McCULLOCH SERVICE BULLETIN

NO. 1632

MODEL SP 40 DATE April 1, 1977

SUBJECT 1. Ignition Switch Kit, P/N 92649 2. Correct CHAIN BRAKE Assembly on 13-level

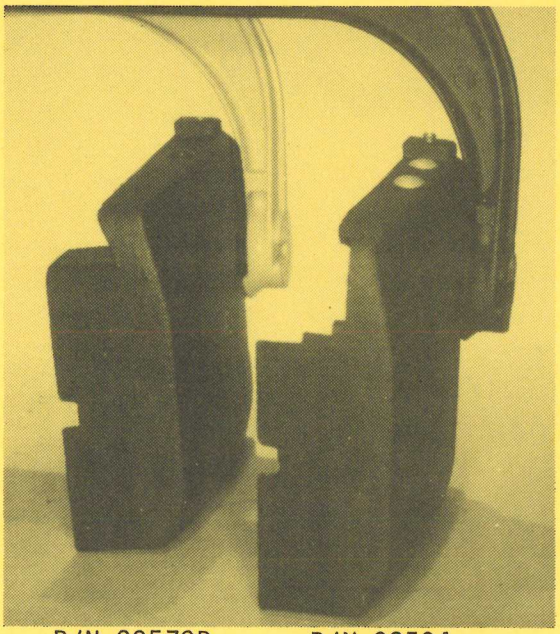
1. Ignition Switch Kit, P/N 92649, is now available as service replacement for SP 40 chain saws with serial numbers prefixed 13-. The new switch has a male connector which replaces screw used to hold ignition wire assembly to terminal. This kit will not backfit on 12-level SP 40 saws. Ignition Wire Kit, P/N 58387, will continue to be used on these models.
